Item ID: D350-689-021

Item Name: Dual High Back Seat Installation - Energy Attenuating Seat Compatible

DART SERVICE INSTRUCTION

TO AMEND INSTALLATION INSTRUCTIONS IIN-D350-689 REV. B AND INSTRUCTIONS FOR CONTINUED AIRWORTHINESS ICA-D350-689 REV. 1

FIGURE 1: UPDATES TO CROSS SECTIONS F-F AND M-M
 With reference to Figures 5 and 7 of IIN-D350-689
 (Figures 25-5 and 25-7 of ICA-D350-689)

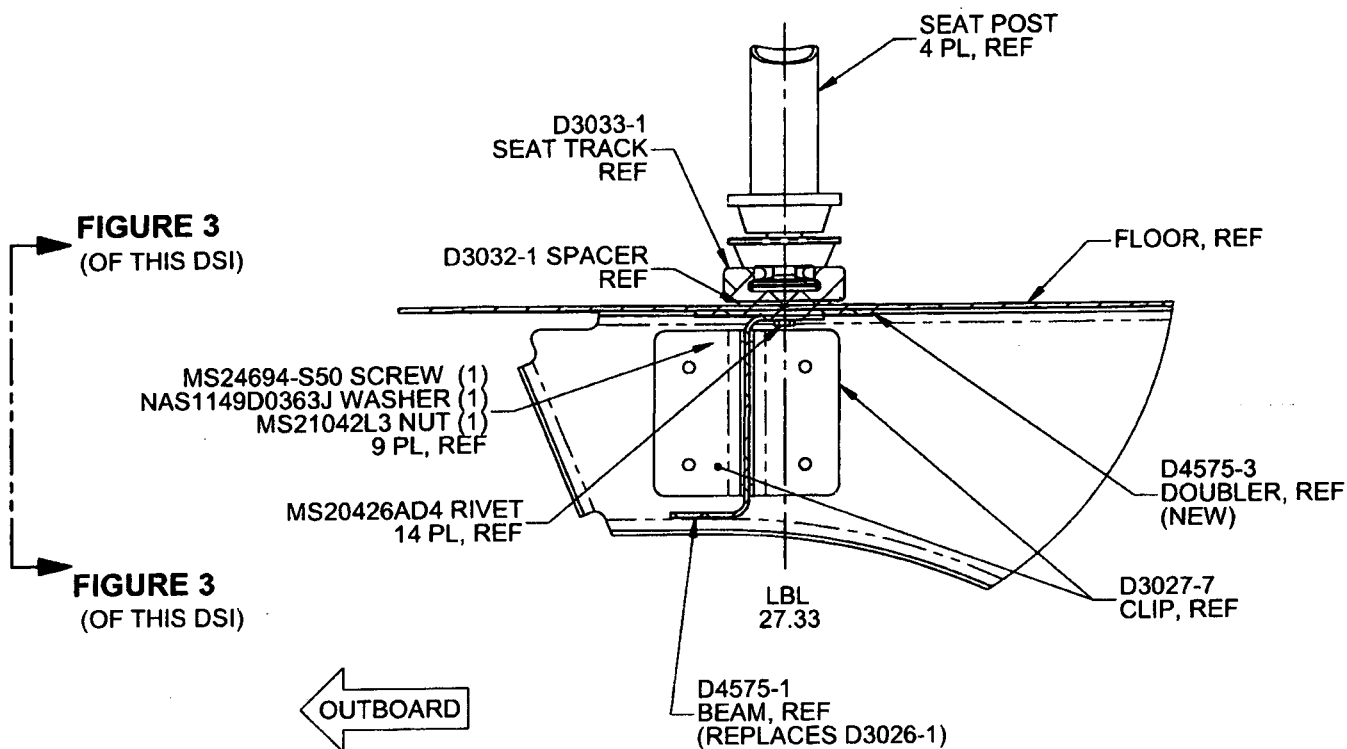
For D350-689-011/-013 at CHG 006/005 and later and D350-689-021/-023 Kits at CHG 005/004 and later, the D3026-1 Channel has been replaced with the D4575-1 Beam and D4575-3 Doubler and the D3234-3 Doubler has been removed. Consequently, the installation instructions for D350-689-011/-013 at CHG 006/005 and D350-689-021/-023 at CHG 005/004 are updated per Section 2.0 of this Service Instruction. The parts list update is shown in Section 4.0 of this Service Instruction. There is a negligible change to the weight and balance.

If there is an existing stringer at LBL 27.33, it will need to be removed from that location. Locate D4575-1 Beam, D4575-3 Doubler, and D3032-1 Spacer as shown in Figure 1 of this Service Instruction. Transfer drill existing holes from the aircraft floor to the D4575-1 Beam, D4575-3 Doubler, and D3032-1 Spacer. Ensure 1.0" to 1.5" rivet pitch and add additional holes if required. If there is no existing stringer, locate D4575-1 Beam, D4575-3 Doubler, and D3032-1 Spacer as shown in Figure 1 of this Service Instruction and drill Ø0.128" holes on a 1.0" to 1.5" pitch.

If there is an existing stringer at LBL 27.33, it will need to be removed from that location. Locate D4575-1 Beam and D4575-3 Doubler as shown in Figure 2 of this Service Instruction. Transfer drill existing holes from the aircraft floor to the D4575-1 Beam and D4575-3 Doubler. Ensure 1.0" to 1.5" rivet pitch and add additional holes if required. If there is no existing stringer, locate D4575-1 Beam and D4575-3 Doubler as shown in Figure 1 of this Service Instruction and drill Ø0.128" holes on a 1.0" to 1.5" pitch.

FIGURE 3: RELIEFS ON D4575-1/-3
(ONLY D4575-1/-3 SHOWN FOR CLARITY)
VIEW LOOKING INBOARD

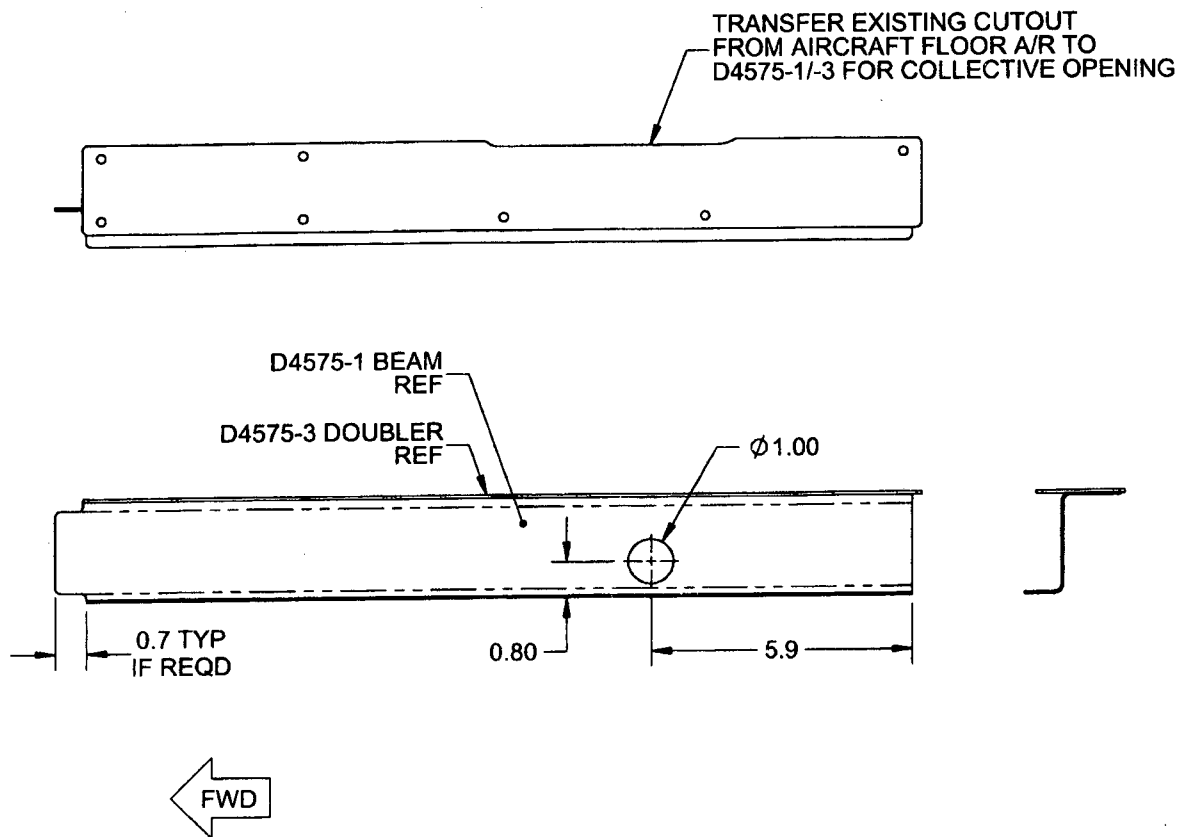
Note: Drill a Ø1.00" (Ø25.4 mm) hole in the D4575-1 Beam to clear extension tube of collective and cutout as required for clearance of collective opening and fwd bulkhead as shown in Figure 3 of this Service Instruction.

Note: Drill a Ø1.00" (Ø25.4 mm) hole in the D4575-1 Beam to clear extension tube of collective and cutout as required for clearance of collective opening and fwd bulkhead as shown in Figure 3 of this Service Instruction.
